Access Compliance Report Public Rights-of-Way (Curb Ramps)

Main Street: BRADBURY_RD Cross Street: WALLINGSFORD_RD Location: NW

ADA ID: RPRK211209135350 Ramp Type: Type 1 - Perpendicular Diagonal Initial Pass/Fail: Fail Overall Compliance: No Severity Score: 15

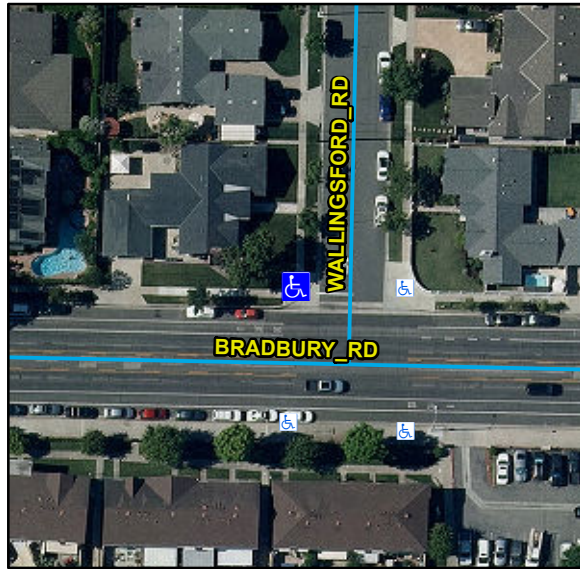
Compliance	Description	Data	Compliance	Description	Data
N/A	Ramp Length (in)	63	N/A	Flare Type LT	
Yes	Ramp Width (in)	48			N/A
No	Ramp Run Slope (%)	8.6	N/A	Flare Slope LT (%)	N/A
Yes	Ramp Cross Slope (%)	1.1	N/A	Flare Traversable LT	N/A
N/A	Landing Present	N/A	N/A	Flare Type RT	
N/A	Landing Length (in)	N/A			N/A
N/A	Landing Width (in)	N/A	N/A	Flare Slope RT (%)	N/A
N/A	Landing Run Slope (%)	N/A	N/A	Flare Traversable RT	N/A
N/A	Landing Cross Slope (%)	N/A	N/A	DWS Provided	N/A
N/A	Landing Movement Obstructed?	N/A	N/A	DWS Contrast	N/A
	Landing Movement Type	N/A	N/A	DWS Length (in)	N/A
N/A	Landing Shared	N/A	N/A	DWS Full Width	N/A
N/A	Clear Space	Yes	N/A	DWS Offset Left (in)	N/A
N/A	Clear Space To Crosswalk (in)	N/A	N/A	DWS Offset Right (in)	N/A
N/A	Marked Crosswalk 1	No	N/A	Marked Crosswalk 2	No
	Crossing 1 Direction	S		Crossing 2 Direction	E
	Marked Crosswalk 1 Width (in)	N/A		Marked Crosswalk 2 Width (in)	N/A

N/A	Ramp Inside Crosswalk 1	N/A	Yes	Ramp Inside Crosswalk 2	N/A
	Crossing 1 Slope (%)	7.1		Crossing 2 Slope (%)	1.3
	Crossing 1 Cross Slope (%)	2.7		Crossing 2 Cross Slope (%)	4.1
N/A	Gutter Ponding	N/A	N/A	Curb Slope	3.9
Yes	Gutter Lip Height (in)	0		Road Run Slope (%)	3.5
N/A	Gutter Run Slope (%)	N/A		Road Cross Slope (%)	3.3
N/A	Gutter Cross Slope (%)	N/A			
Yes	Overall Surface Condition: Acceptable		Yes	Perp Joint Present	Yes
	Cross Gutter Present?	Yes		Spandrel Present?	Yes
	Replace Cross Gutter?	No		Replace Spandrel?	No

Remove & Replace Curb Ramp With Two New Directional Ramps or Equivalent.

R304.2.2, STD 1115
